Draft Supplemental Generic Environmental
Impact Statement

Tri-County Business Park
13700 Tri-County Business Park
Chaffee, NY 14030

E&M Engineers and Surveyors P.C.
P.O. Box 159
Springville, NY 14141

Rev. April 11, 2013

**EXHIBIT 2
SITE PLAN**

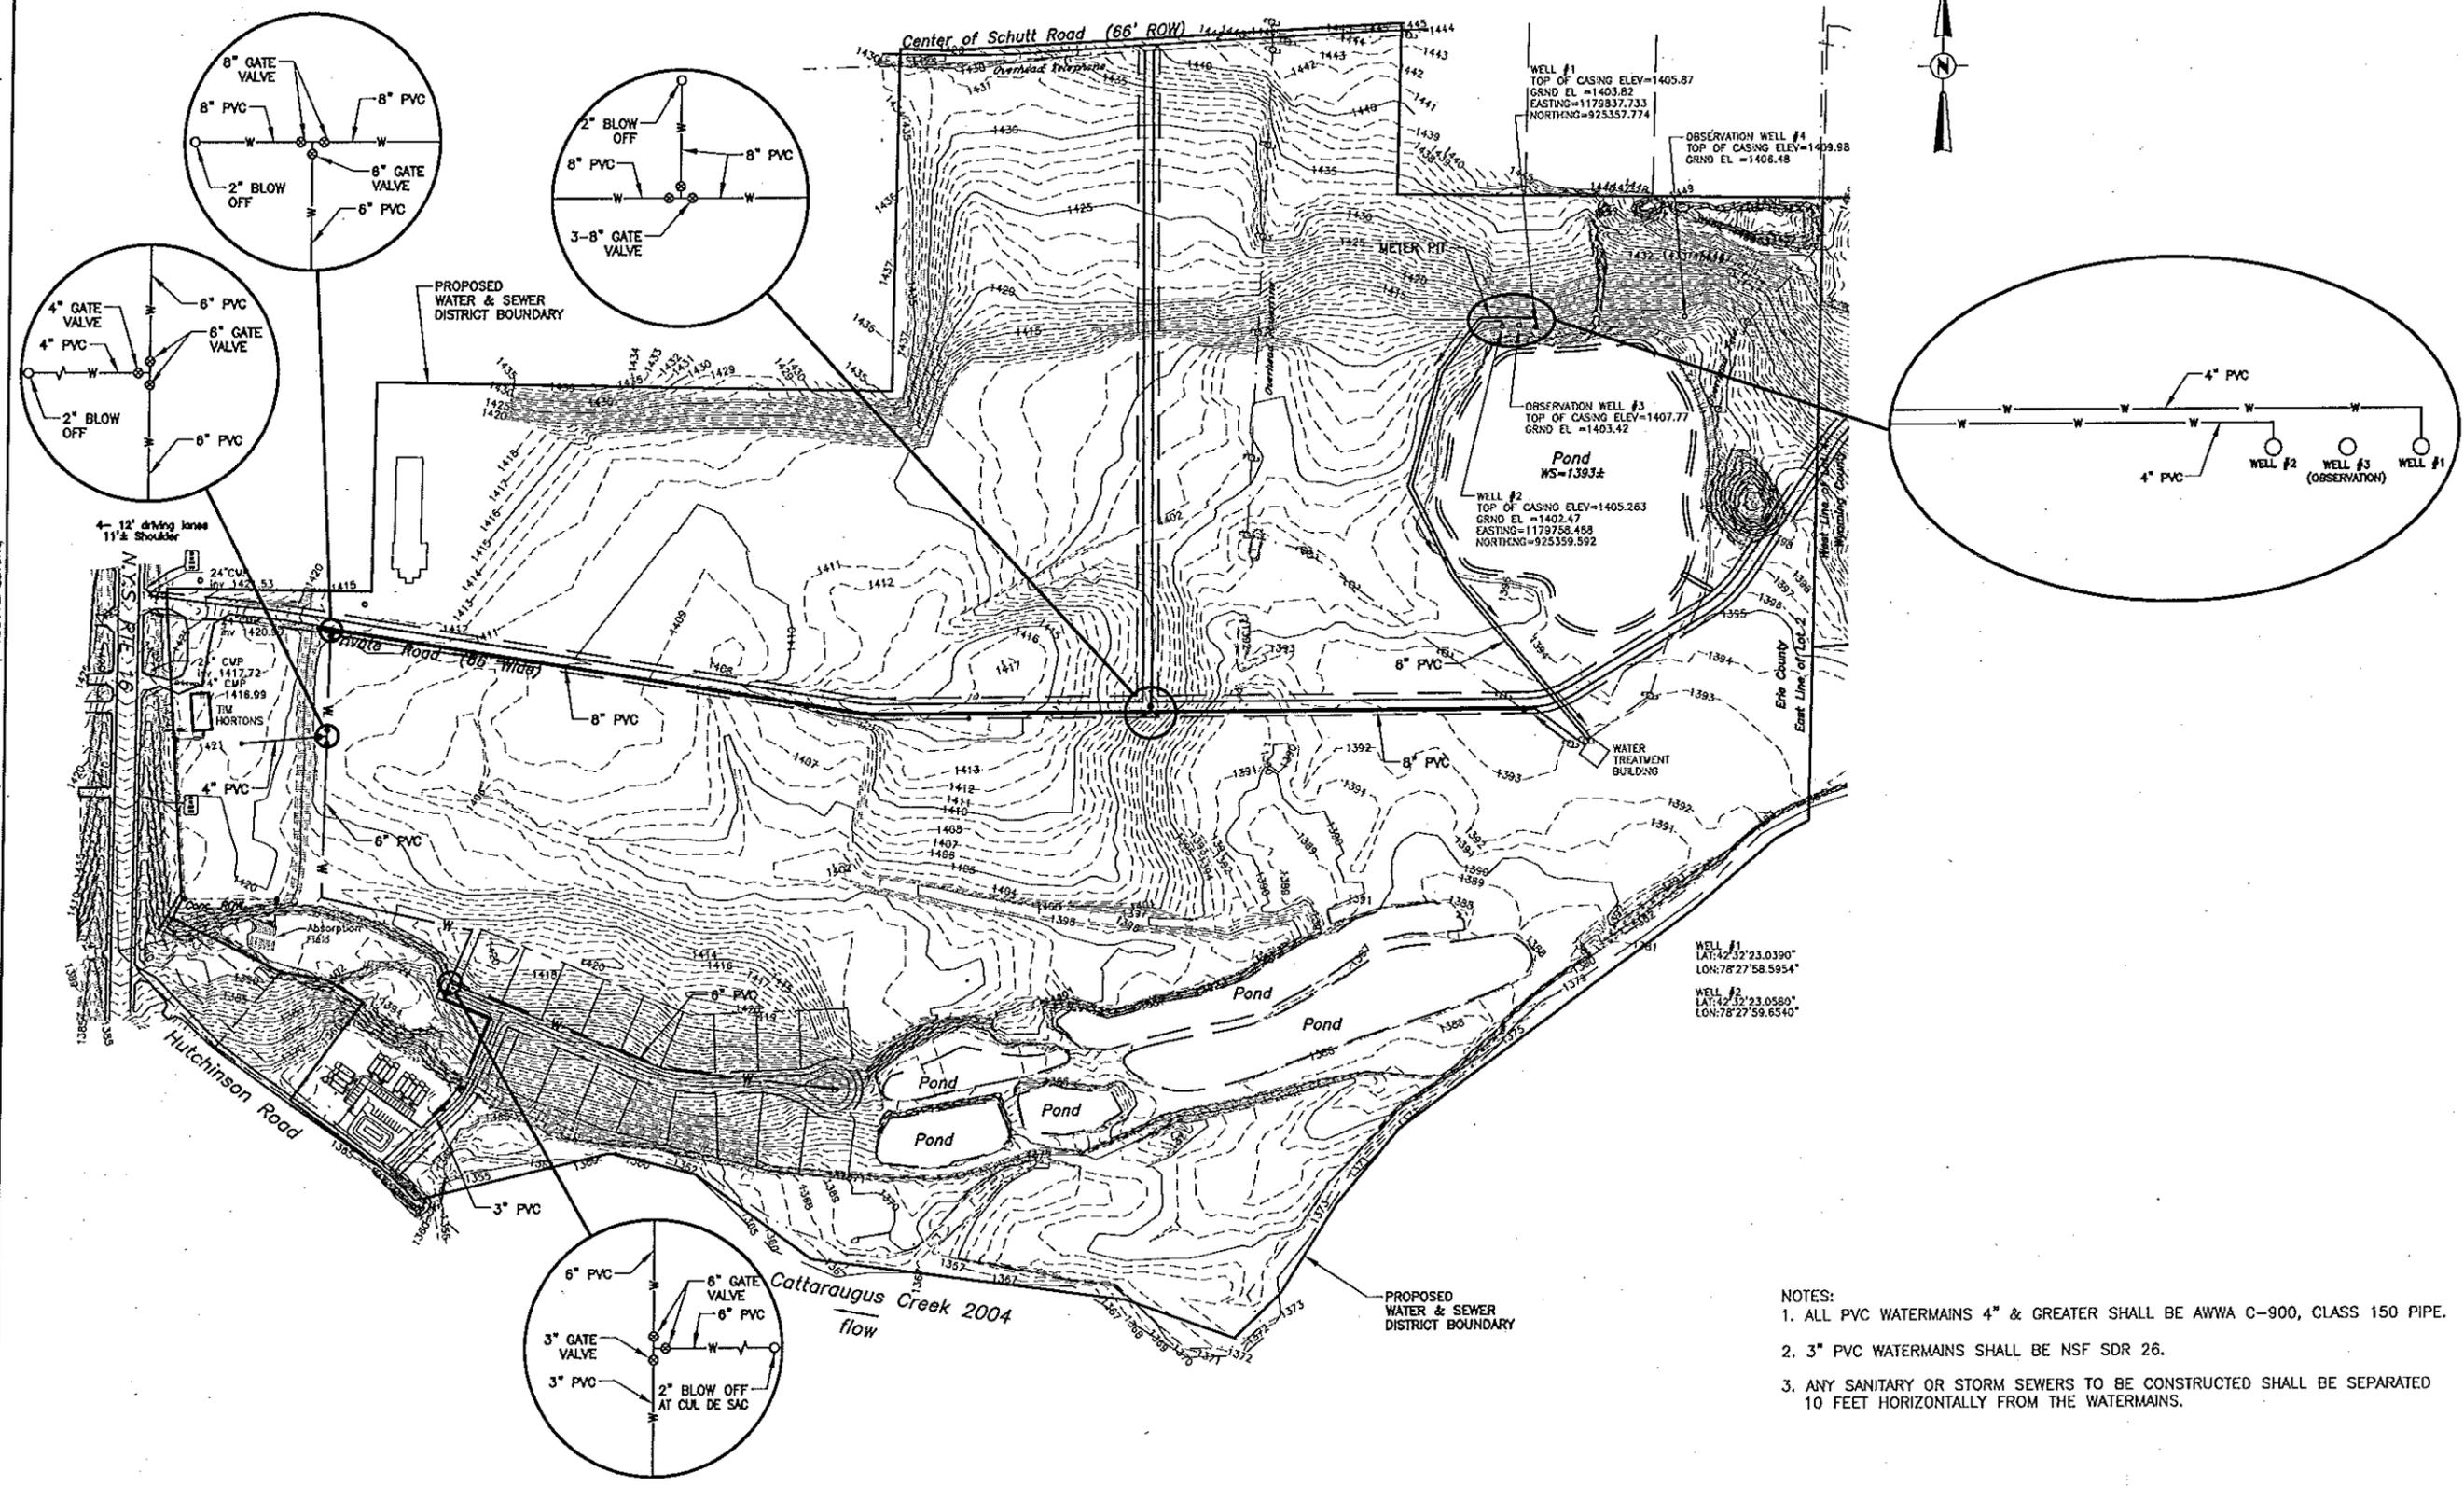
- b. The plan sheet "Subdivision Site Plan Exhibit 2" has a drawn line labeled "100-year flood plain Zone A" using the approximate Zone A line from FIRM 360256 0036 C dated January 16, 2003, whereas the SDGEIS (page 3) says that the BFE Certificate places the flood elevation at 1367.00. Does the proposed 1367 BFE change as flood water flows from the upstream to the downstream reach of the site? The Zone A approximate line and the non-verified elevation are not compatible and cannot be accepted as provided until FEMA approves the BFE.

- 5) Applications for a C-LOMR -F are being completed along with all substantiating information. Copies will be forthcoming upon submission to FEMA to assure the Town that the development will be reasonably safe from flooding. The DSGEIS was modified on pg 5 to include a discussion on the C-LOMR-F and makes note that a Final LOMR-F will be necessary to obtain final occupancy permits.
